# SERVICE BULLETIN

## 30<sup>th</sup> April, 2010

### LABEL POSITIONS FOR EWP FLY BOOM

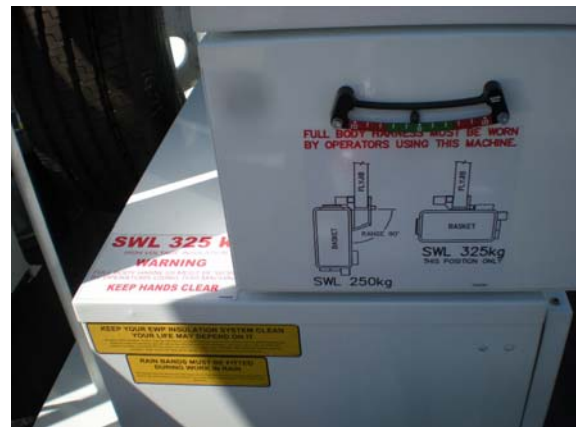
Pictured below is EWP Model TF17M as delivered April, 2010. You will note there are no labels on the fly boom in the area between the insulation markers. This is a requirement of **AS1418.10 (Int.)-2004. Section 1.12.5.17.2 Insulator location identifiers** - that states labels should not be applied to the insulated insert surface.

Any labels that were originally placed on the fly boom insulator have been relocated onto the top of the jackleg on the right hand side and cabinet work directly in front of that jackleg. (Please refer to photos below indicating new location of labels).

**LABELS LOCATED ON TOP OF RIGHT HAND JACKLEG AND CABINET WORK DIRECTLY IN FRONT OF THE JACKLEG.**
